August 8, 2025
ES-9607.02

**Subject: Response to Land Use Review Comments
Cheshire Property
7615 East Mercer Way
Mercer Island, Washington**

City File No. CA025-005 SUB 2

K_s Calculations - West Slope

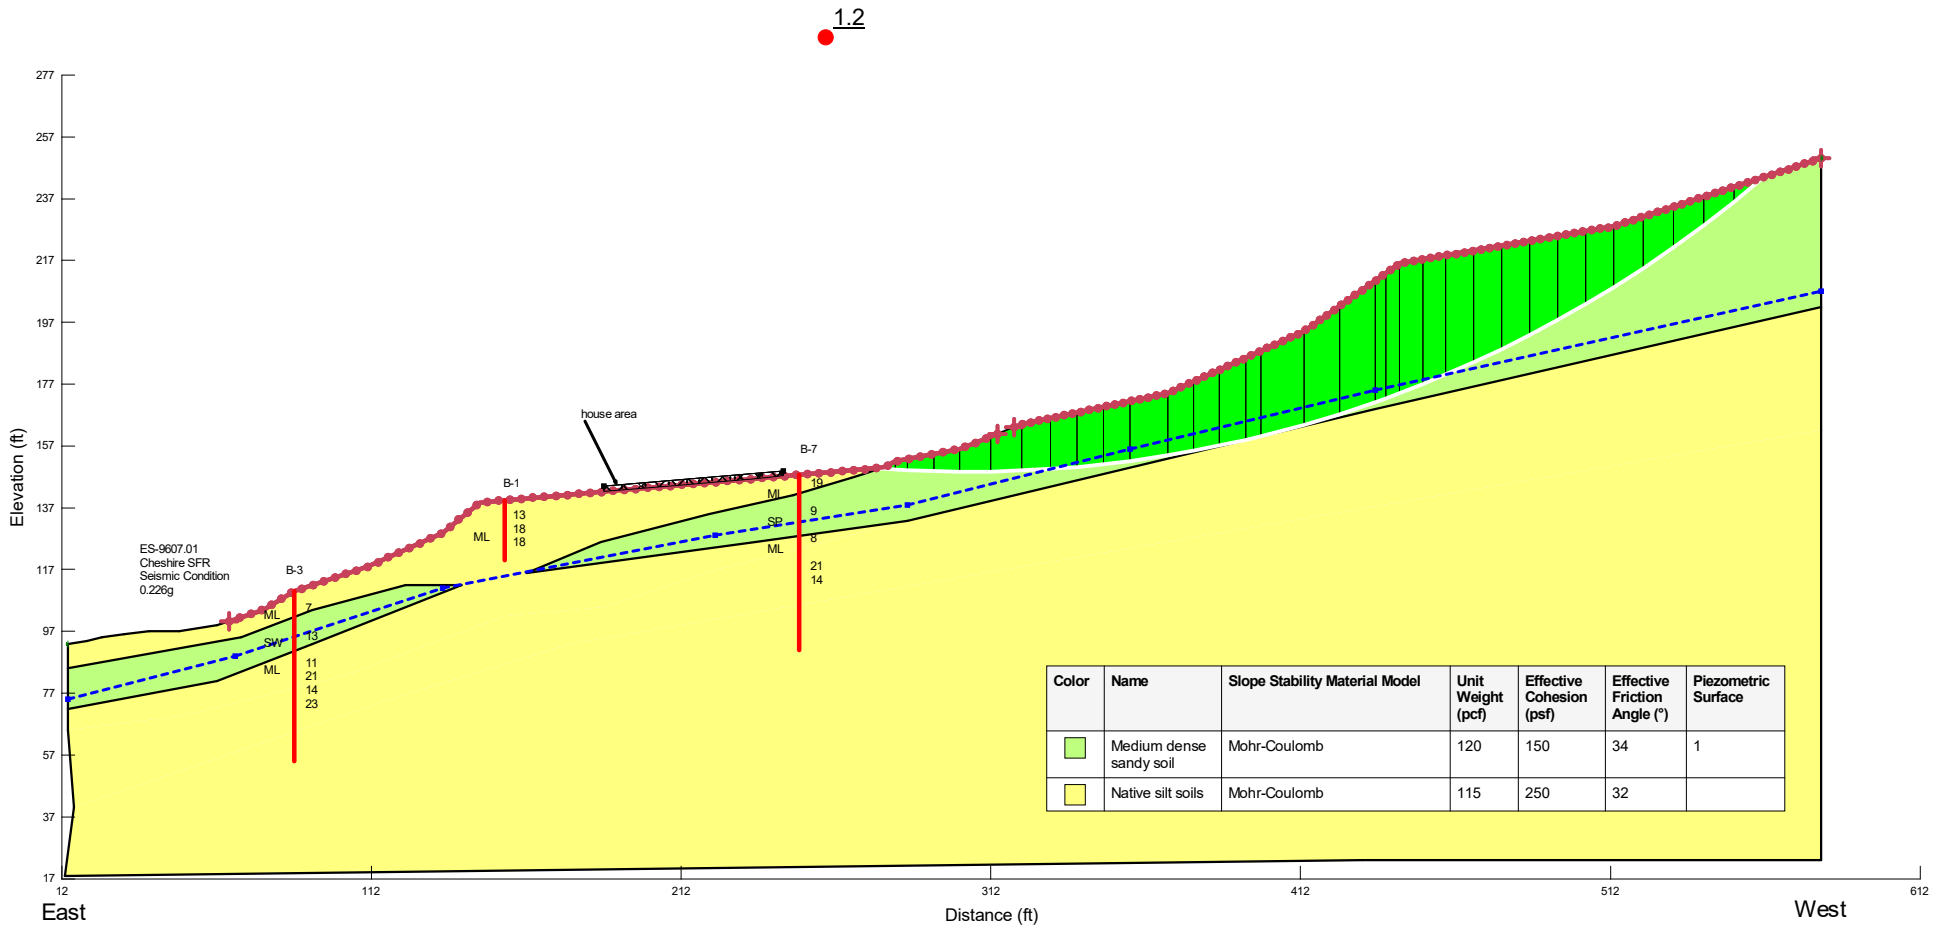
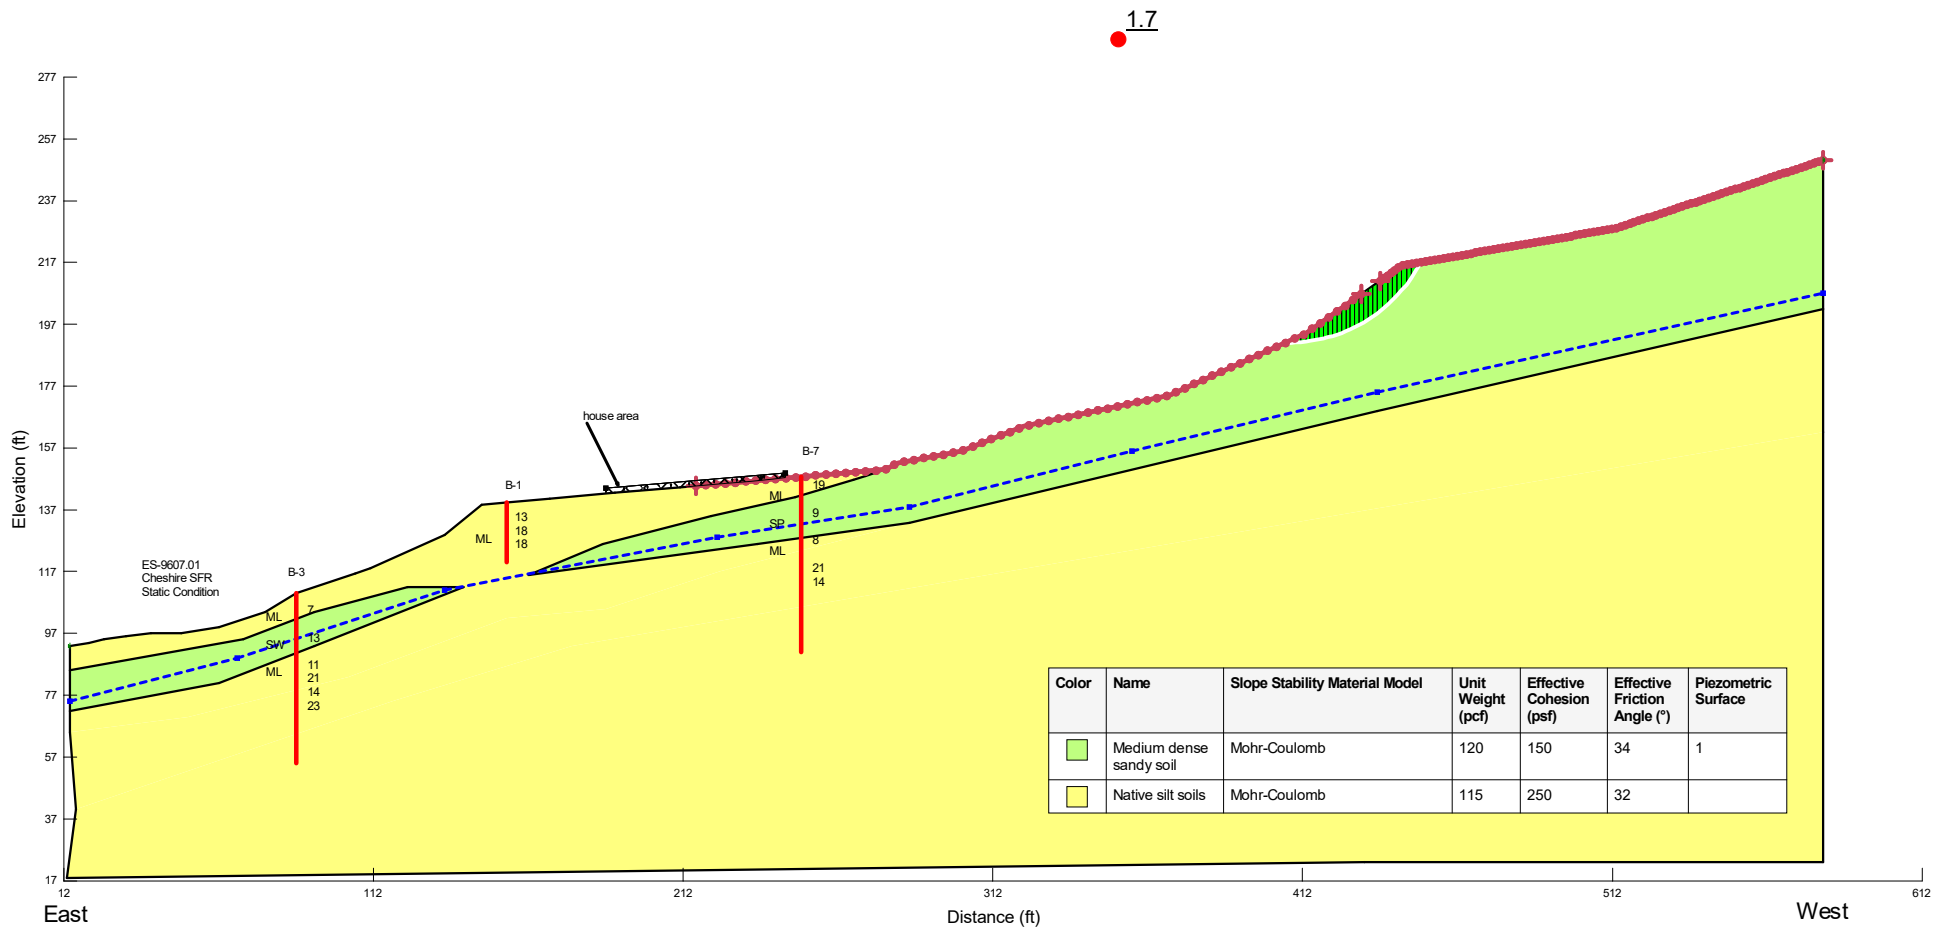
Please revise slope stability analyses to conform to local standard of practice and to the FHWA reference that indicates that "the peak shear strength is generally assumed to be equal or less than the peak static strength".

Please provide the calculation for the slope height reduction factor and the average peak acceleration that takes into account spatial incoherence. Please provide revised slope stability analyses using this average peak acceleration to verify that the FOS is a minimum of 1.1 for the western slope as indicated in ESNW response above.

To evaluate the ascending slope to the west of the building pad, we assumed that this slope represents the intact slope (non-mobilized). A slope reduction calculation was completed for this slope and using average assumed soil parameters the model indicated a minimum FOS value of 1.3 for seismic conditions.

Updated slope stability modeling results are attached along with slope height reduction calculations.

To evaluate the ascending slope to the west of the building pad, we assumed that this slope represents the intact slope (non-mobilized). A slope reduction calculation was completed for this slope and using average assumed soil parameters the model indicated a minimum FOS value of 1.3 for seismic conditions.

Hole No.=B-7 Water Depth=12 ft

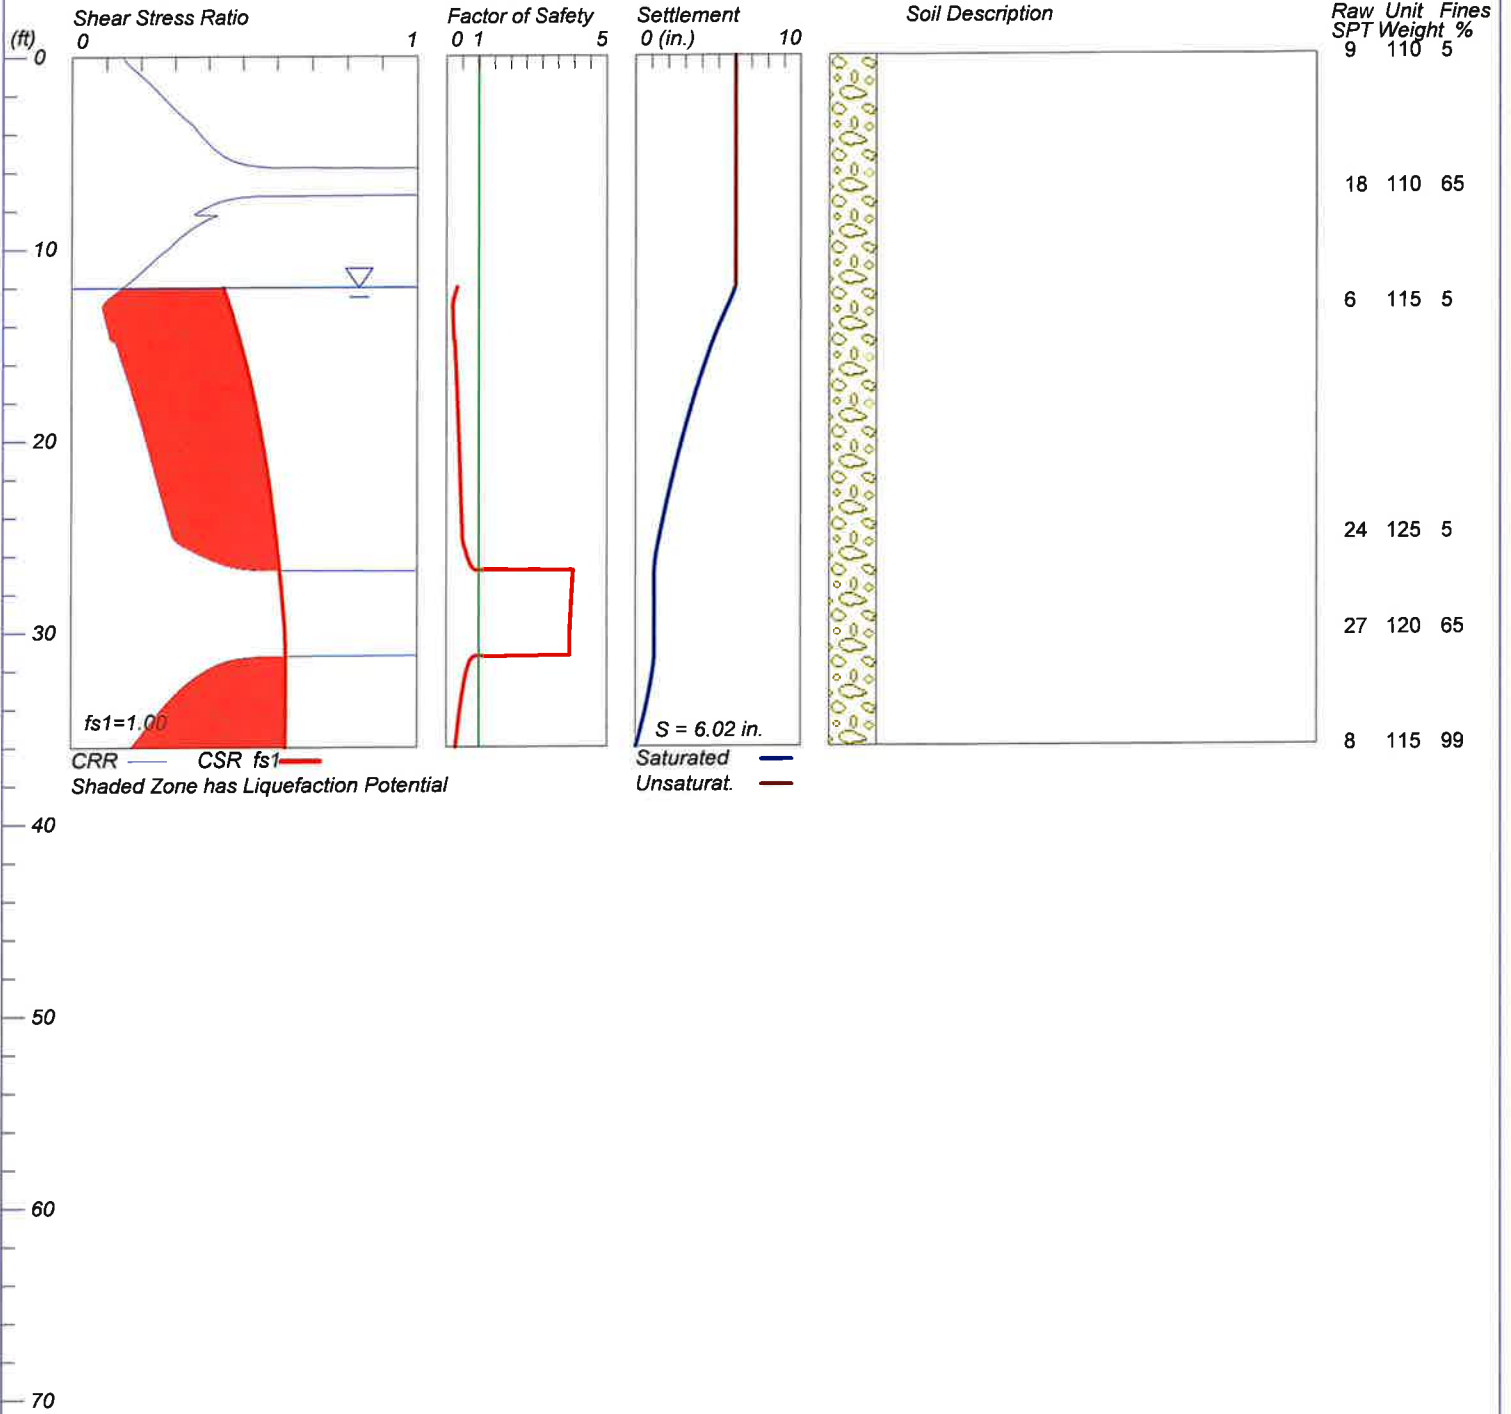
The groundwater conditions in borings B-6 and B-7, located to the west and north of the proposed structure seem to be very similar. The effects of liquefaction indicated for the B-7 conditions should be considered in the stability analyses. Please provide residual strength estimates for the liquefiable layers for review and include those strengths in revised stability analyses. Please provide an assessment for lateral spreading and/or debris flow failures using these residual strengths. Please provide associated calculations of lateral spreading and/or debris flow deformations. Please include mitigation recommendations for potential post-liquefaction effects. For example, if debris flow failures are anticipated, please determine debris flow volumes and runout and determine whether the proposed structure could be physically impacted by the debris flow. If so, please provide mitigation measures or provide impact loading values for the structural engineer to consider in the structural design. On the downslope side of the residence, please indicate whether lateral spreading or debris flow would undermine the structure and provide mitigation recommendations.

Based on site-specific modeling of the site, the slope to the east may subside between three to six inches in response to liquefaction of saturated discrete sandy layers at depth. Slope stability modeling suggests that most instability is limited to the upper soils and therefore, lateral spread is not expected to occur. The building will be supported by pipe piles and helical anchors; therefore, subsidence of soils to the east of the building are expected to be limited to yard space and patio areas that are not pile-supported. This information has been distributed to the design team and is considered in the current submittal.
